SEWAGE DISPOSAL SYSTEM

MARYLAND STATE DEPARTMENT OF HEALTH

SUBDIVISION Holsinger Property ROAD 760 Long Corner Road LOT _____

PROPERTY OWNER Jeff and Sue Harrison

INDICATE NORTH. — NAME ADJOINING ROADWAY AS BASE LINE.

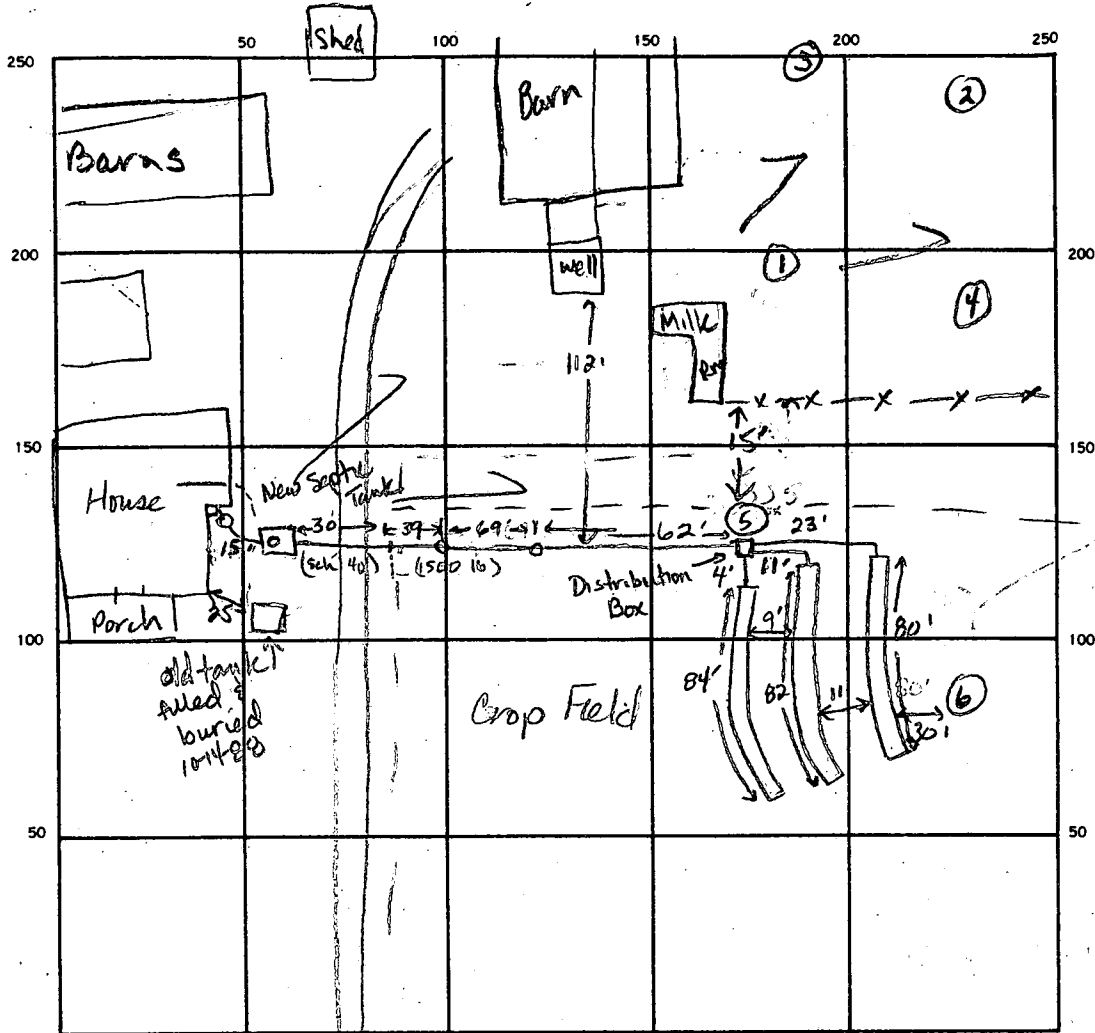
SEPTIC TANK. LEVEL 1000 gal CLEANOUTS 1 at house, 1 on s. tank

DISTRIBUTION BOX. LEVEL OK w/ baffle

DRAIN FIELD/TILE FIELD. DEPTH 3.5 3.5 3.5 FT. TRENCH WIDTH 3 FT. INLET DEPTH 20' 20' 20'

EFFECTIVE GRAVEL DEPTH 1.5 1.5 1.5 FT. TOTAL LENGTH 84 82 80 FT.

NUMBER OF TRENCHES 3 ONE SIDEWALL/BOTTOM AREA 252 246 240 SQ. FT.

ABSORBENT AREA 738 SQ. FT.

REMARKS 10-14-80 OK to cover all work. JEN.

INDICATE NORTH - NAME ADJOINING ROADWAY AS BASE LINE.
Long Corner Road

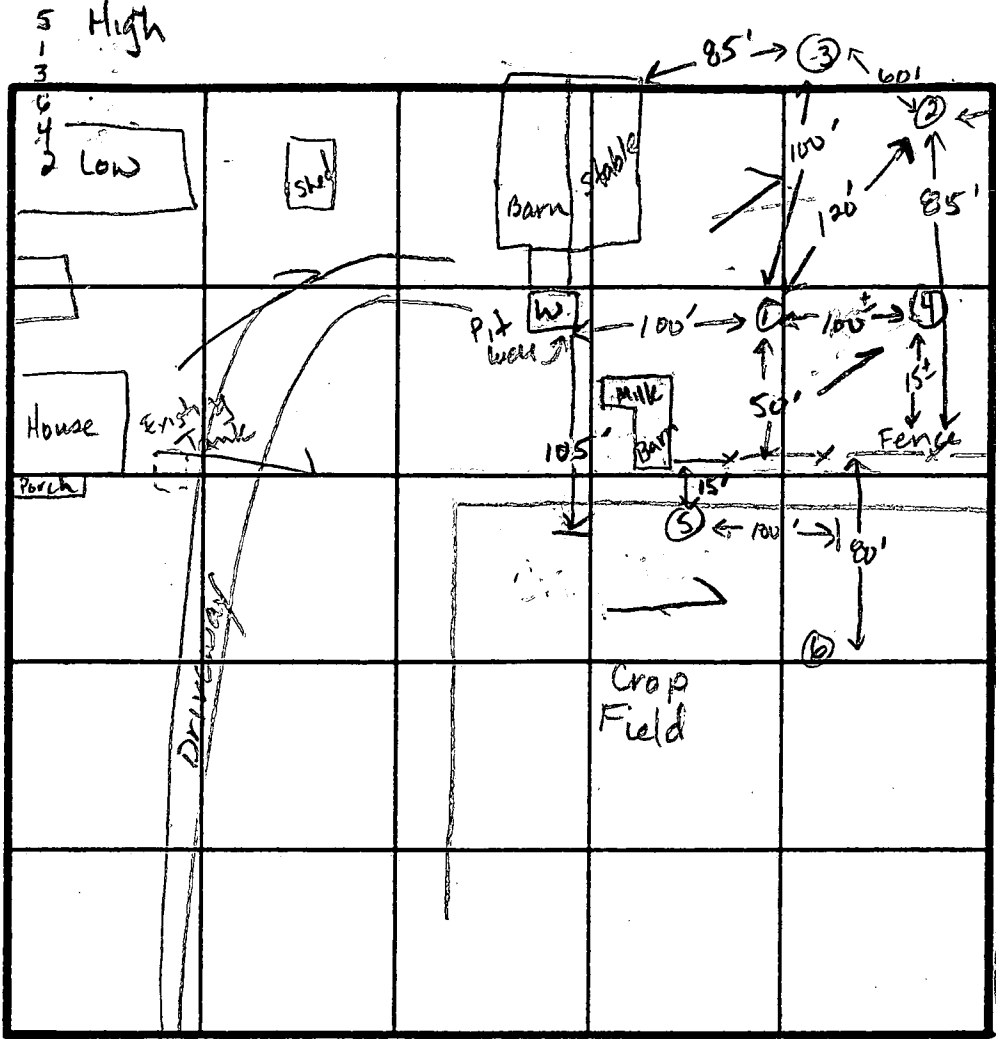
REASONS FOR REJECTION OR HOLDING 10-13-88 Repair area downslope of well and 100 ft away. Initial system w/ bottom at 3.5 ft. Future system w/ bottom at 5.5 ft. SHALLOW SYSTEM ONLY. JENADEAN.

REMARKS: Rocky soils. Keep system as shallow as possible.
 Repair area, trenches to be deeper w/ bottom at 5.5 ft.

X = 18 min
 Inlet at 2.0'
 Bottom at 3.5'
 240 sq ft / bdrm
